SUNDRY NOTICES AND REPORTS ON WELLS

BOPCO L.P. respectfully request to ammend point four of the 8pt drilling program from the original APD that was approved on 07/11/2012. Point four of the drilling program will now read as stated in the attached page. The subsequent diagrams are also attached.

POINT 4: PRESSURE CONTROL EQUIPMENT (SEE ATTACHED DIAGRAM 2)

13-5/8" X 3-M BOPE (2 Rams and Rotating Head) & Closed Loop System Equipment Schematic Diagram 2

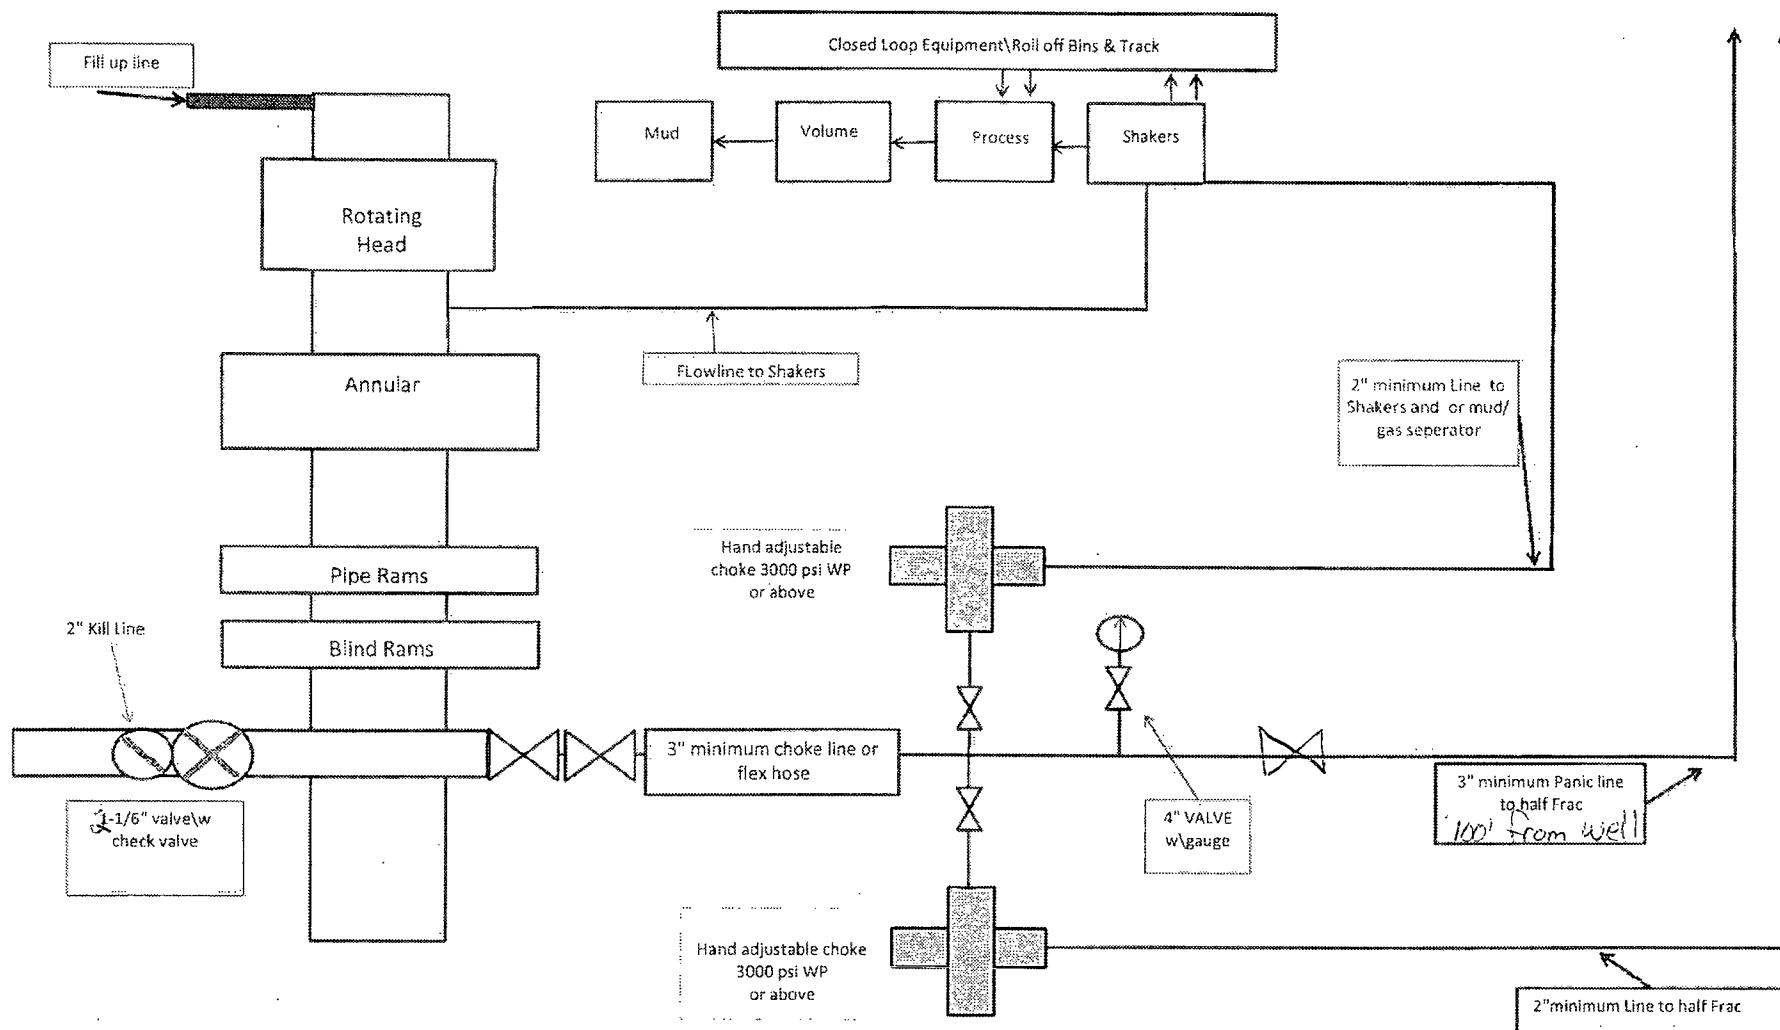
BOPCO, L.P. would like to request a variance to use an armored, 3.5", 5000 psi WP flex hose for the choke line in the drilling of the well if the rig is equip with hose. (See specification for hose that might be used, attached with APD exhibits). This is rig equipment and will help quicken nipple up time thus saving money without a safety problem. The hose itself is rated to 5000 psi, and has 5000 psi flanges on each end. This well is to be drilled to 14,218' MD (8,095' TVD) and max surface pressure should be +/-1781 psi as prescribed in onshore order #2 shown as max BHP minus 0.22 psi/ft. Thus, 3000 psi BOPE is all that is needed for this well. **Please refer to diagram 2 for choke manifold and closed loop system layout. If an armored flex hose is utilized, the company man will have all of the proper certified paper work for that hose available on location.**

Variance approved to use flex line from BOP to choke manifold. Check condition of flexible line from BOP to choke manifold, replace if exterior is damaged or if line fails test. Line to be as straight as possible with no hard bends and is to be anchored according to Manufacturer's requirements. The flexible hose can be exchanged with a hose of equal size and equal or greater pressure rating. **Anchor requirements, specification sheet and hydrostatic pressure test certification matching the hose in service, to be onsite for review.** If the BLM inspector questions the straightness of the hose, a BLM engineer will be contacted and will review in the field or via picture supplied by inspector to determine if changes are required (operator shall expect delays if this occurs).
